**TOWN OF NEWBURGH
PLANNING BOARD
TECHNICAL REVIEW COMMENTS**

PROJECT: GARDNERTOWN COMMONS
PROJECT NO.: 2016-03
PROJECT LOCATION: SECTION 75, BLOCK 1, LOT 21
REVIEW DATE: 6 APRIL 2017
MEETING DATE: 6 APRIL 2017
PROJECT REPRESENTATIVE: JCM PLANNING ENGINEERING

SITE PLAN APPROVAL DRAWINGS

GARDNERTOWN COMMONS

TEMPORARY RISER & ANTI-VORTEX DEVICE 3

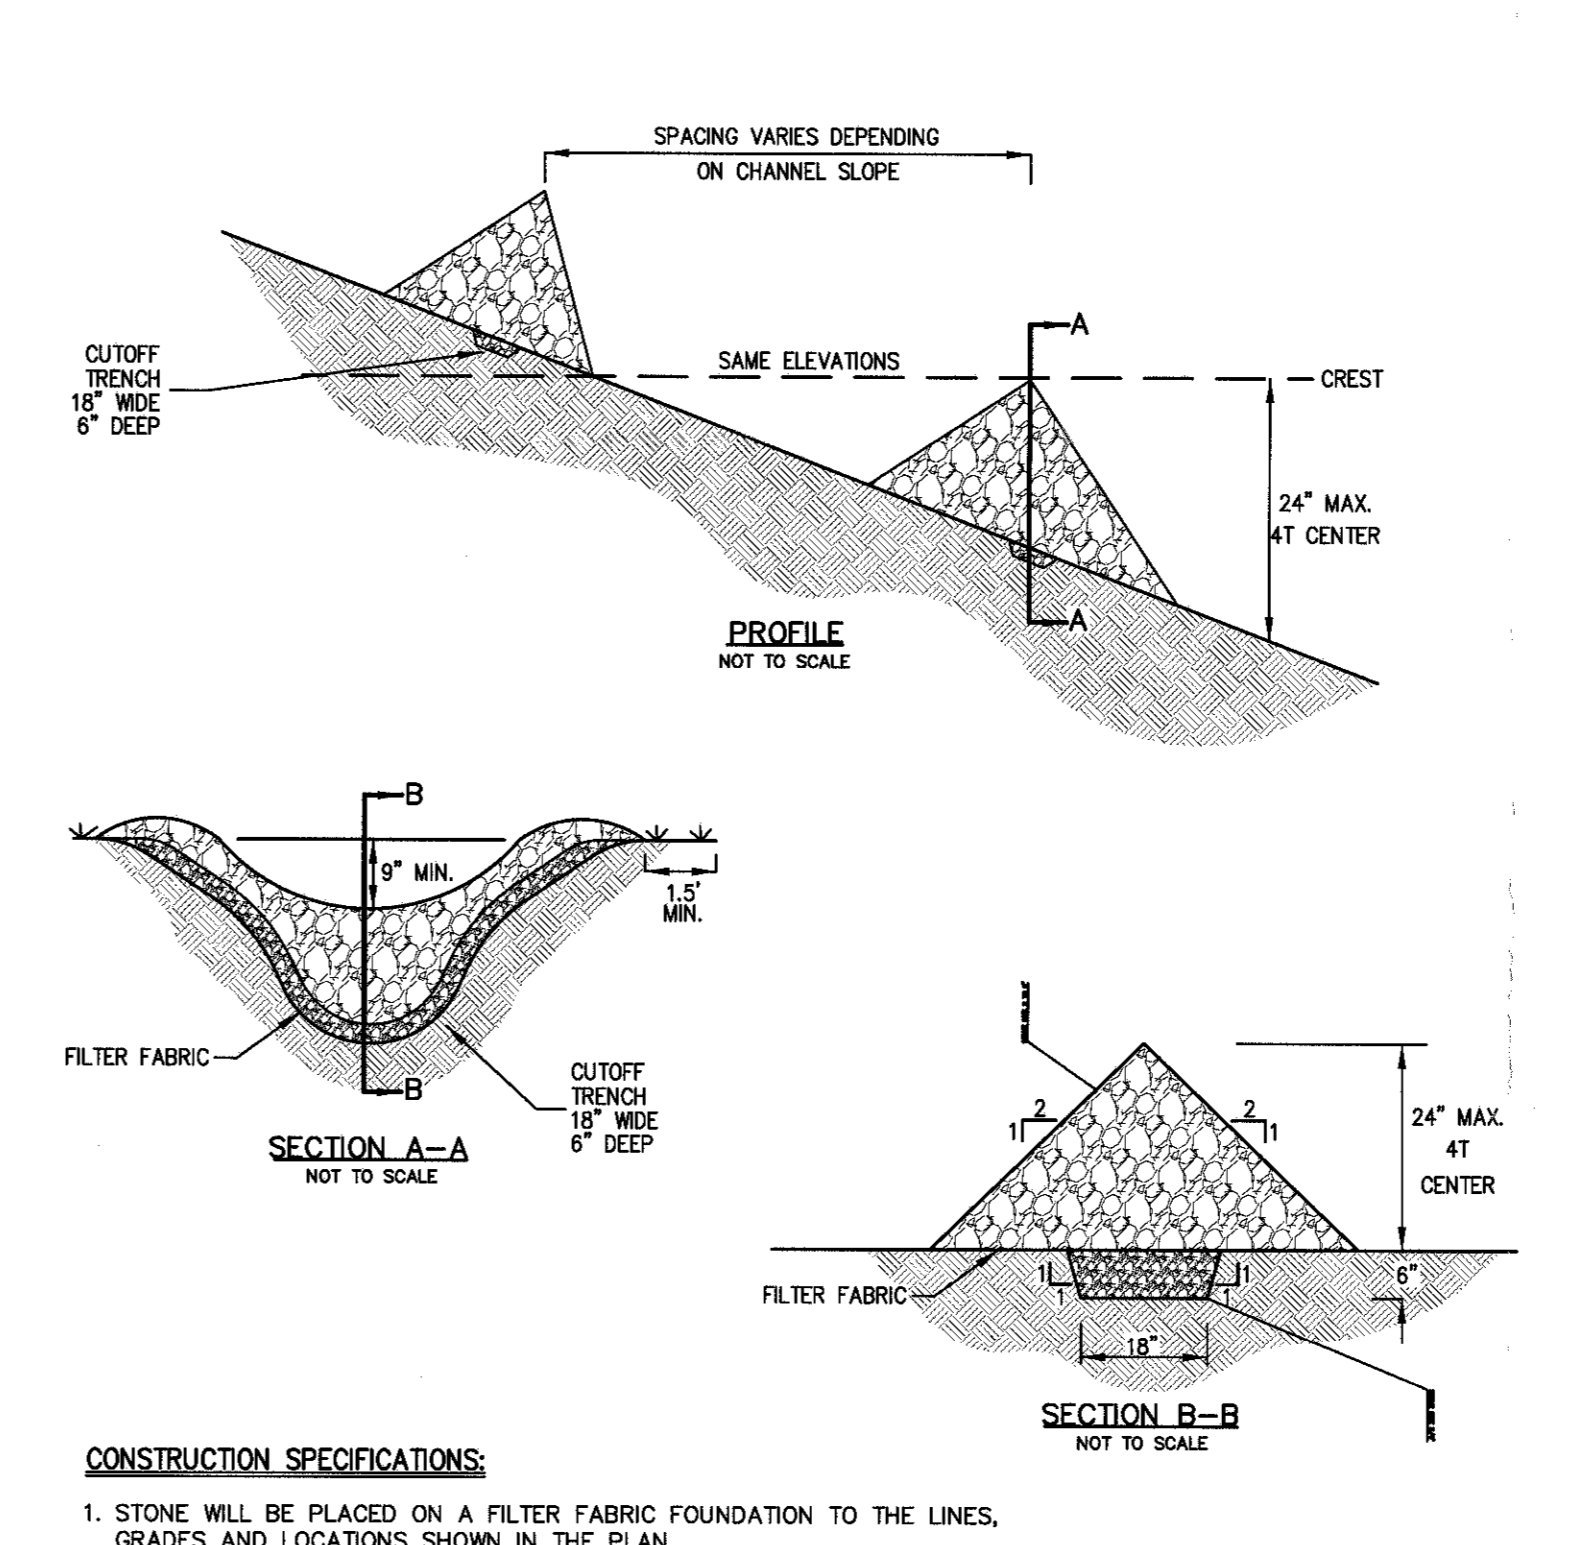
- j) Anti vortex riser detail references a table for sizing of the devices. Location of this table should be noted.

TEMPORARY SEDIMENT BASIN DETAIL 13

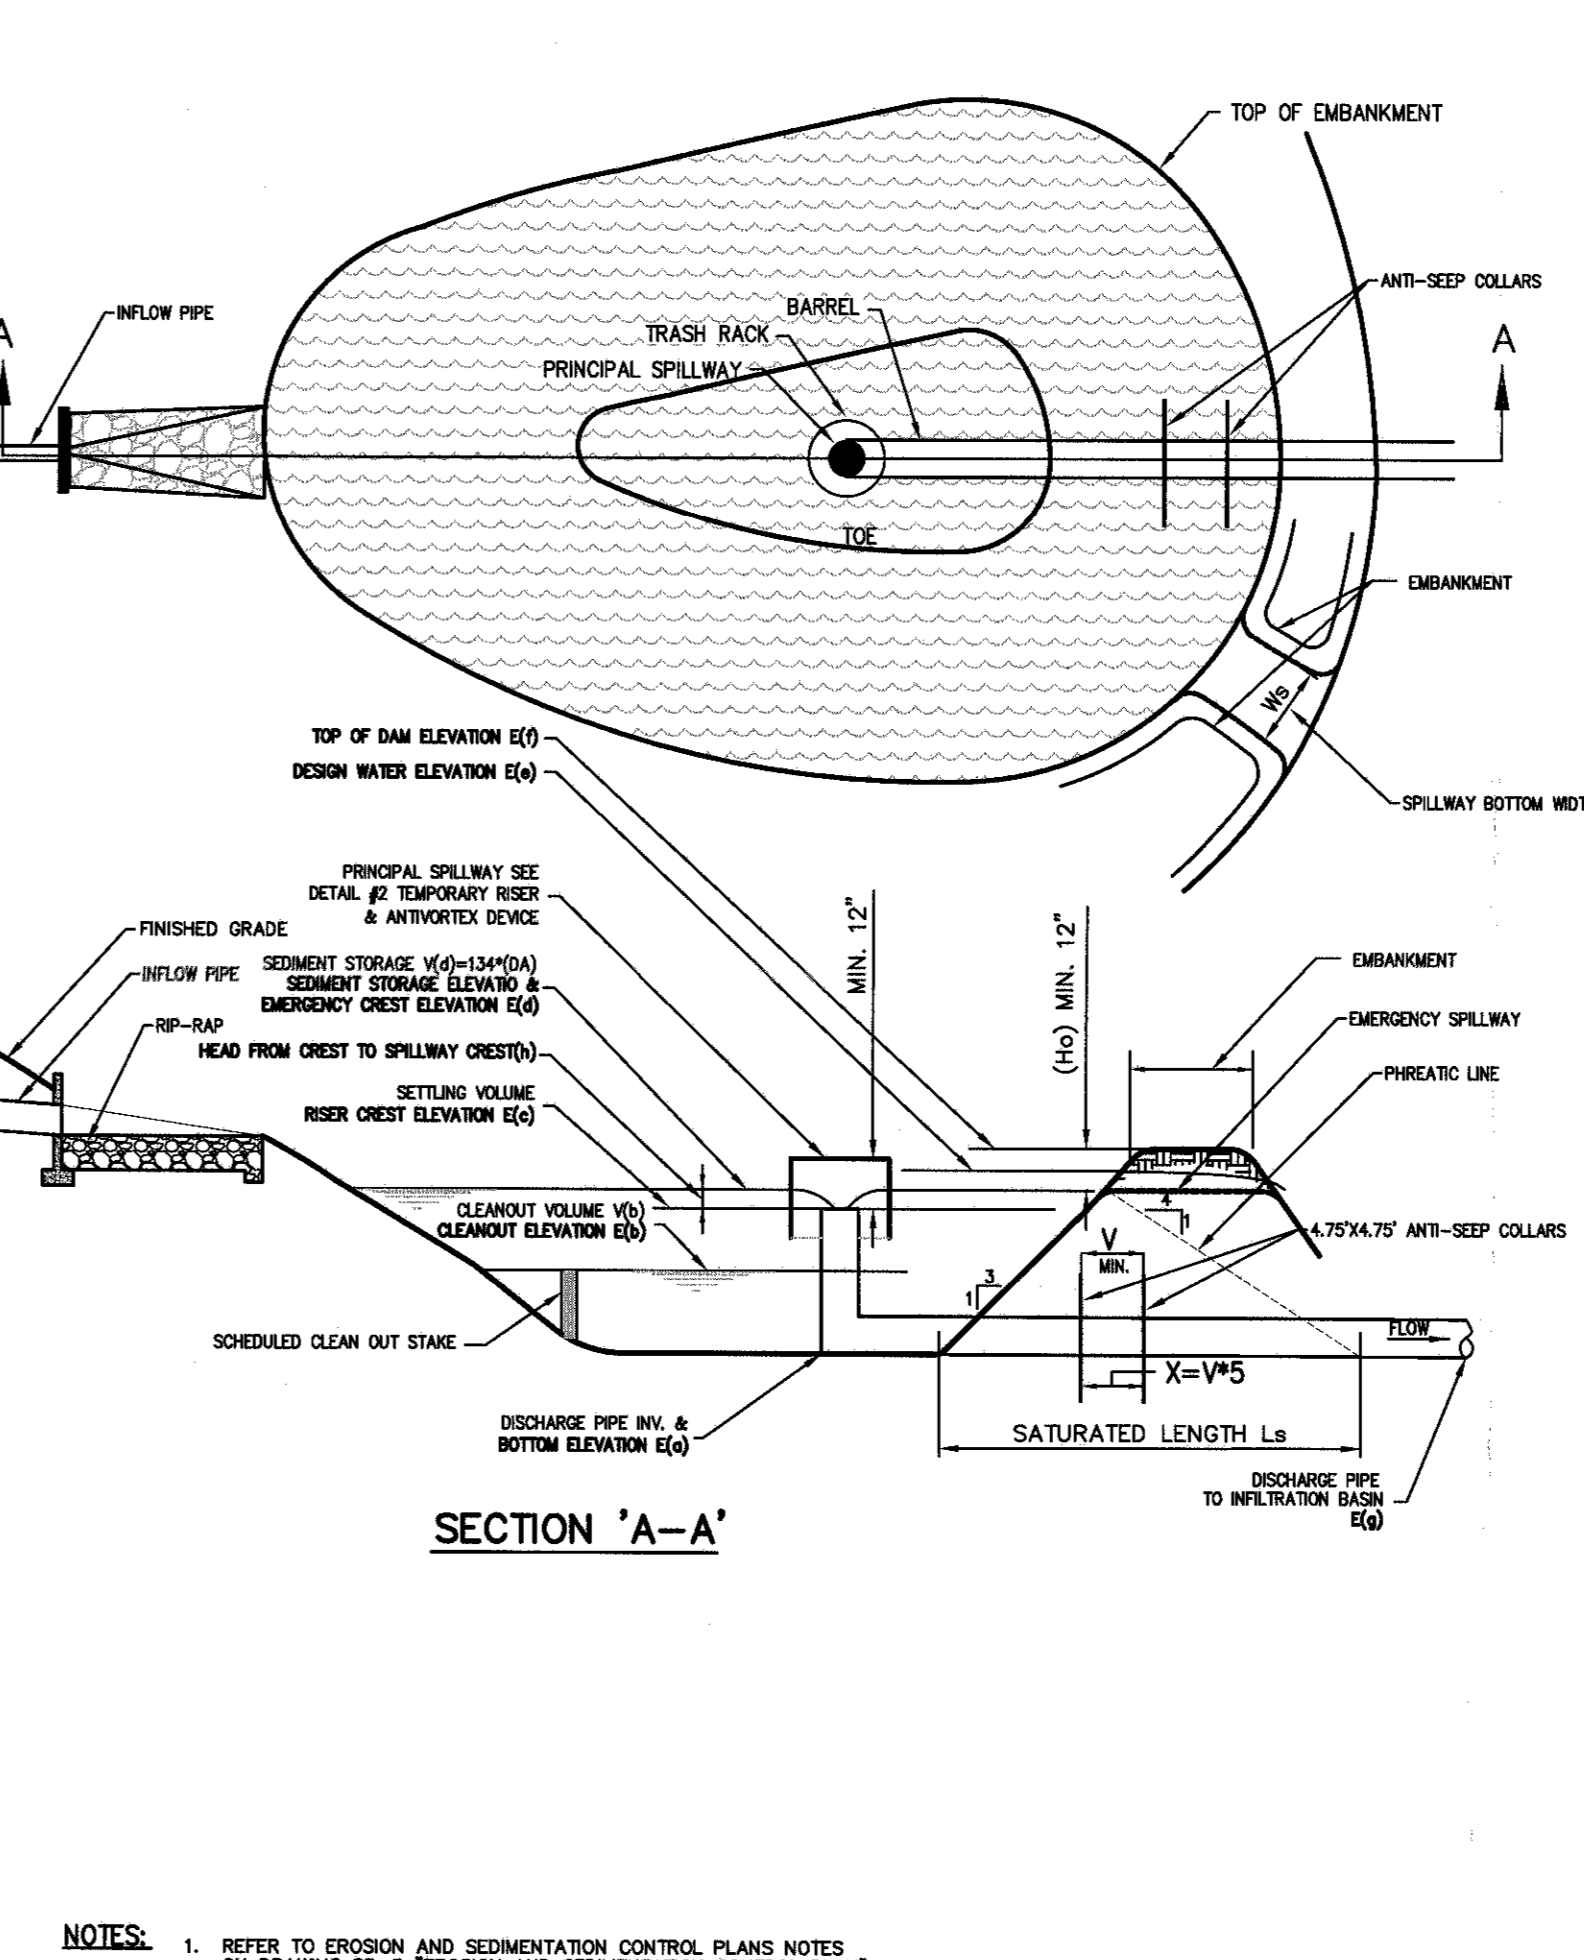
- k) Temporary sediment basin detail requires additional information. Also references Erosion and Sediment Control Plan as SP5 which should reference SP7.

SEGMENTAL BLOCK EARTH RETENTION WALL (TO BE DESIGNED BY OTHERS) **41**

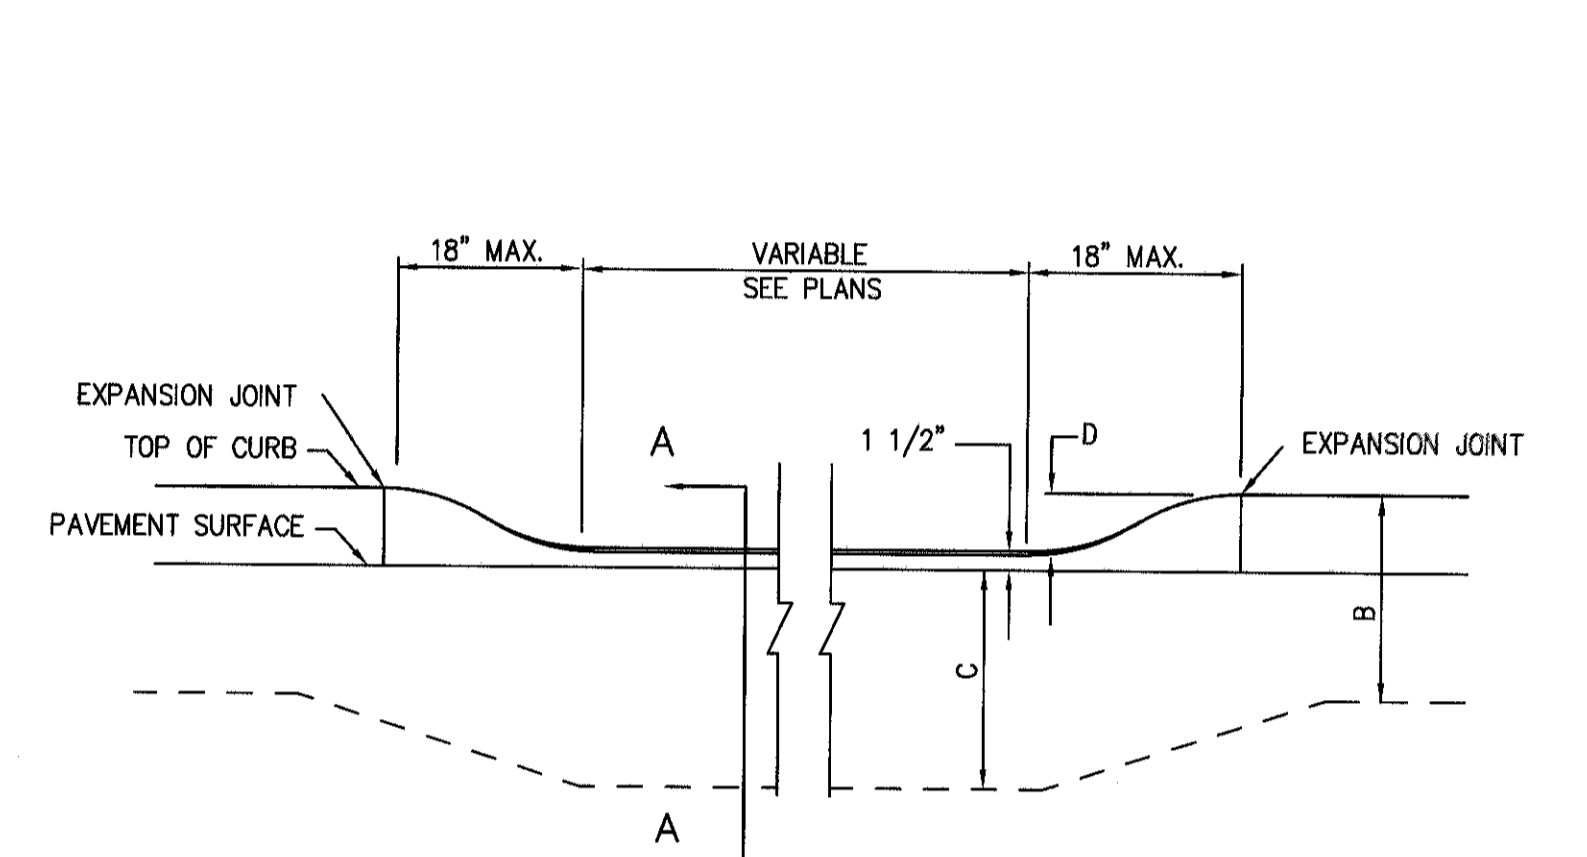
2. The revised stormwater management plan must be developed into a Stormwater Pollution Prevention Plan prior to final approval.
3. Extensive retaining walls have been proposed based on modified grading on the site. Vehicle protection and fencing must be depicted on the details.
